PROJECT: Project No. C009(822); Key No. 09822; I-84, Gowen Rd IC

SUBJECT: Barrier Modification Request

Knife River requests to use G-2-A-1 detail barrier, modified as described below, in lieu of the Montana 606-60 detail concrete barrier rail.

PROPOSED MAX BFT OPENING TO 20' RAIL

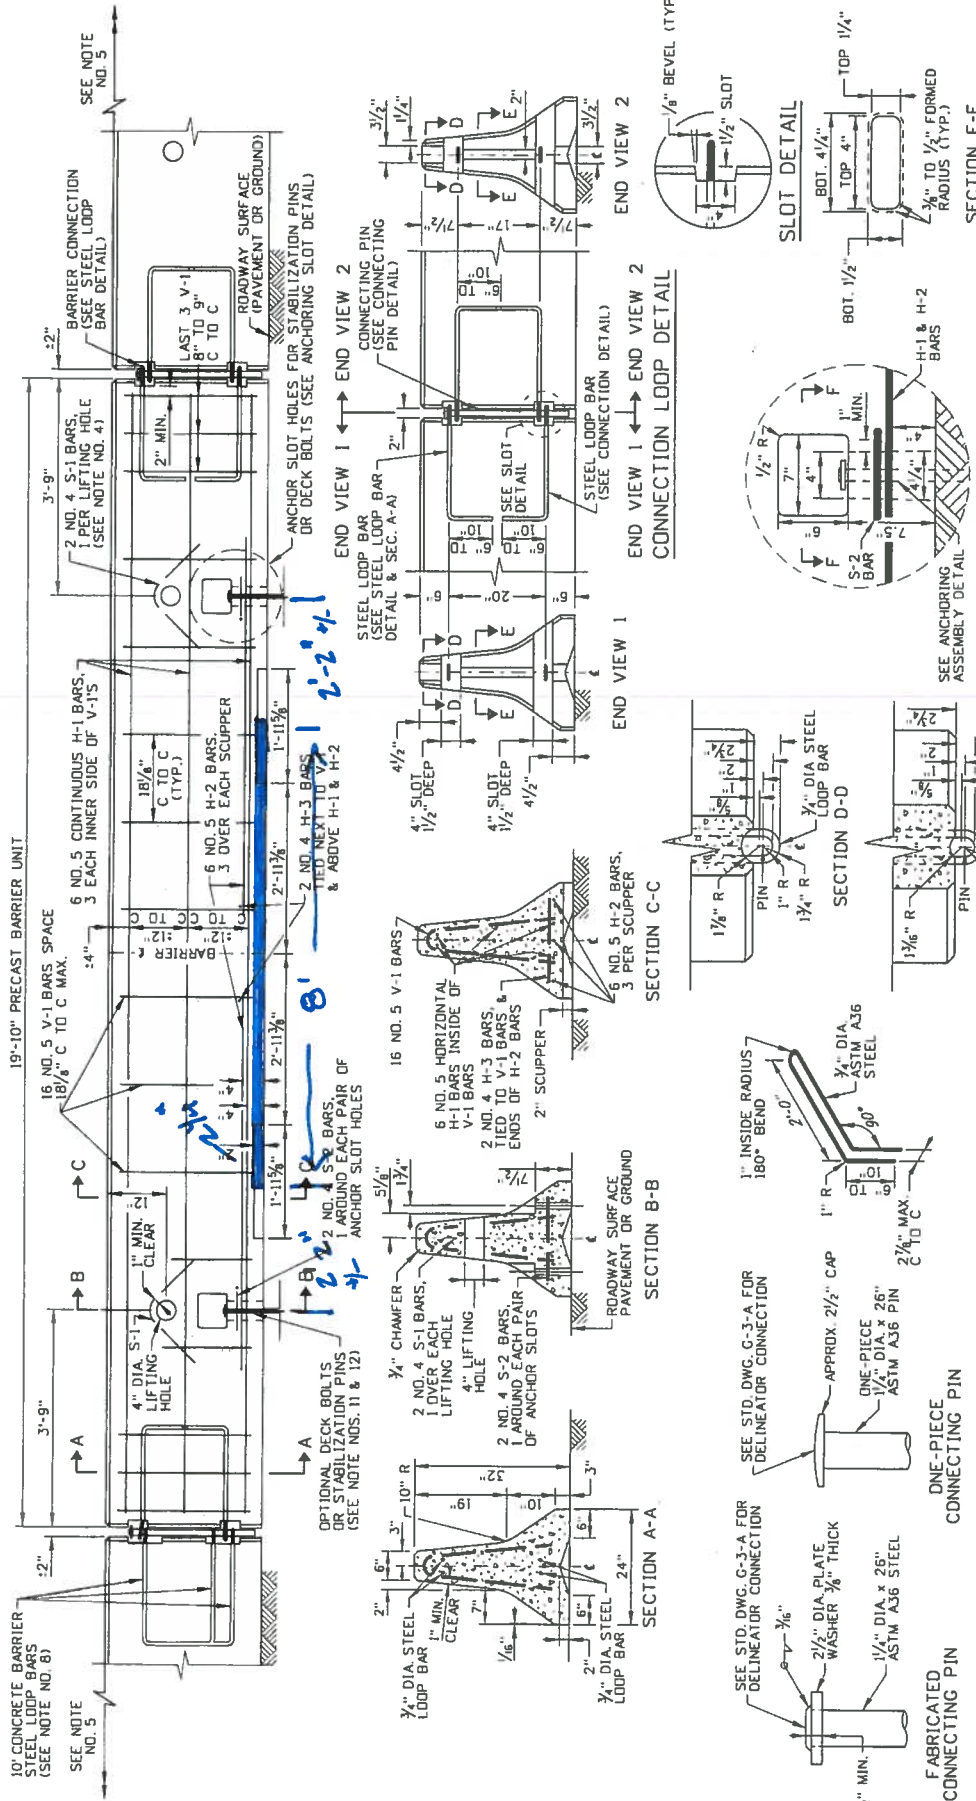
2. G-2-A-1, 20 ft concrete barrier
 - a. Modify the barrier opening at the bottom of the barrier to allow a single opening 8' wide by 2-1/4" tall centered in the barrier, or two openings, each 4' wide by 2-1/4" tall centered between the longitudinal centerline of the barrier and the anchoring slot details on the two respective halves of the barrier.
 - b. Either configuration, the single 8' or double 4', would provide roughly 0.076 square feet of opening per linear foot of barrier, exceeding the maximum provided by the Montana 606-60 rail.

PROPOSED MODIFICATION TO 10' RAIL

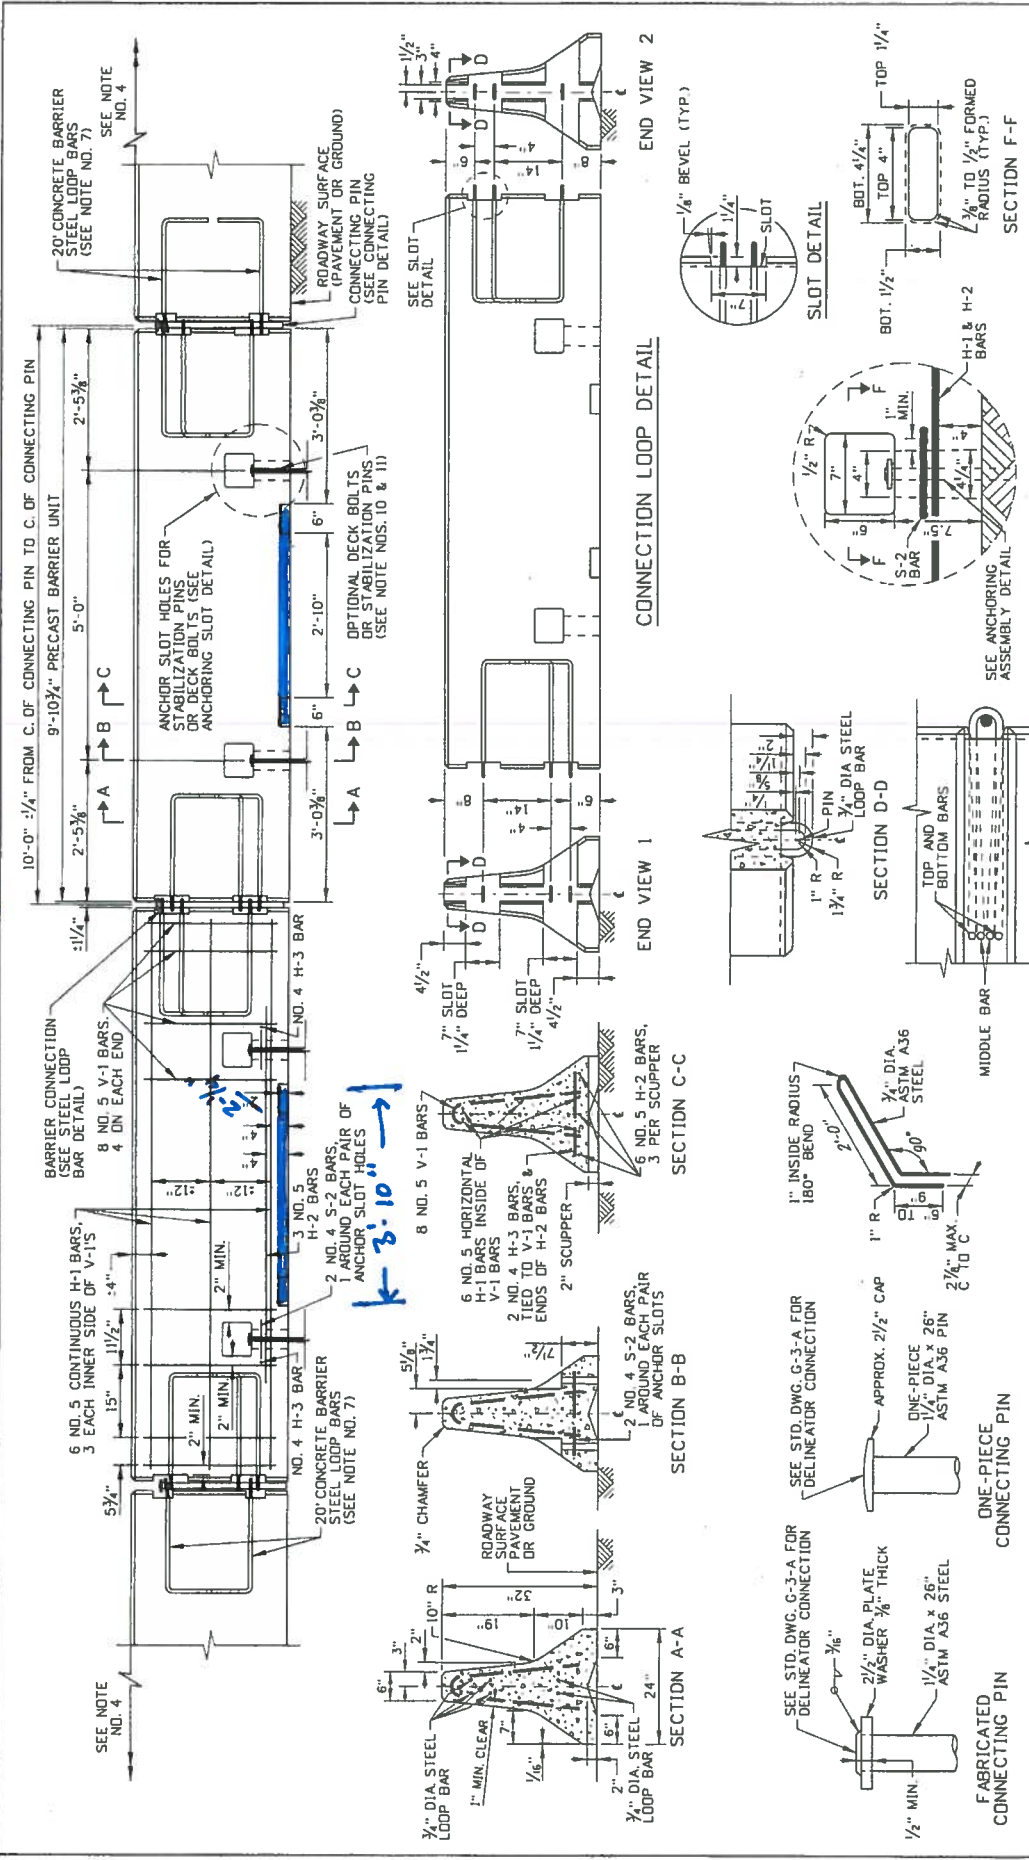
1. G-2-A-1, 10 ft concrete barrier
 - a. Modify the barrier opening at the bottom of the barrier in accordance with the Montana 606-60 detail, 3'-10" wide by 2-1/4" tall opening centered in the barrier. This detail, incidentally, is very similar to the ITD standard G-2-A drawing, which is the same width, but slightly taller at 3".
 - b. The Montana 606-60 rail provides 0.072 square feet of opening per linear foot of barrier. This same opening ratio would be provided, at a minimum, using the 3'-10" by 2-1/4" opening for the G-2-A-1 barrier.
